Access Compliance Report

Public Rights-of-Way

Intersection ID: 10336	Main Street: CALLAHAN_ST	Cross Street: POLK_ST	Location:	W
ADA ID: F7DA7D9FC591	Ramp Type: PerpDiag	Initial Pass/Fail: Fail	Overall Compliance: No	Severity Score: 22.5

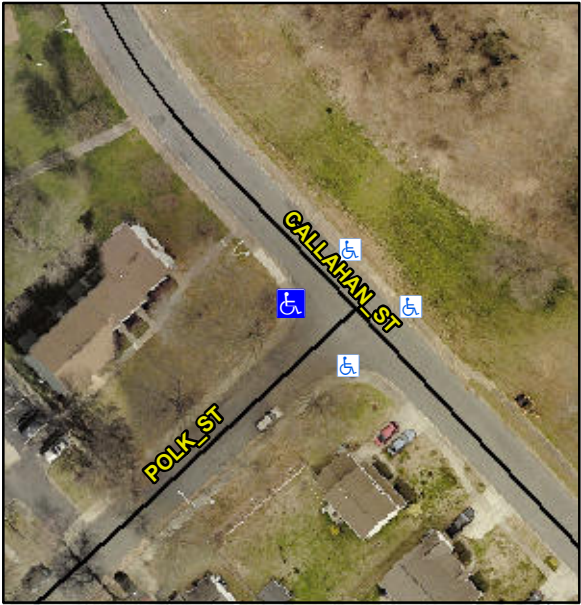
Codes/Mitigation Info/Possible Solution			Field Measurements/Component Compliance		
	Possible Solutions:		Compliance	Description	Data
	Remove & Replace Curb Ramp With Two New Directional Ramps or Equivalent.		No	Ramp Length (in)	65.0
			No	Ramp Width (in)	45.0
			N/A	Flare Type LT	N/A
			N/A	Flare Slope LT (%)	N/A
			N/A	Flare Traversable LT?	N/A
			N/A	Landing Length (in)	N/A
			N/A	Landing Width (in)	N/A
			N/A	Landing Slope (%)	N/A
			N/A	Landing X Slope (%)	N/A
<p>Surveyor Notes:</p> <p>N/A</p> <p>PROW/ADA:</p> <p>Not Found, R304.5.1, R304.2.2, R304.5.3</p>			N/A	Flare Type RT	N/A
			N/A	Flare Slope RT (%)	N/A
			N/A	Flare Traversable RT?	N/A
			N/A	DWS Provided?	N/A
			N/A	DWS Contrast?	N/A
			N/A	DWS Length (in)	N/A
			N/A	DWS Full Width?	N/A
			N/A	DWS Offset (in)	N/A
			N/A	Gutter Ponding?	N/A
			N/A	Gutter Lip Ht (in)	N/A
<p>Street 1 Name</p> <p>Stop Condition-Street 2</p> <p>Street 2 Name</p> <p>Stop Condition-Street 1</p>			No	Painted X Walk1?	No

X Walk 1 Direction	To SE
			N/A	X Walk 1 Width (in)	N/A
				X Walk 1 Slope (%)	0.5
				X Walk 1 X Slope (%)	4.5
			N/A	Ramp inside XWalk1?	N/A
				Road Slope (%)	2.3
				Road X Slope (%)	6.6
			N/A	Any Obstructions?	N/A
				Obstruction Type	
<p>Total Cost:</p> <p>\$ 3200.00</p>			N/A	Storm Grate/Utility Hazard?	N/A
				Storm Grate/Utility Type	
			N/A		N/A
			Yes	Surface Condition? (G/P)	Good
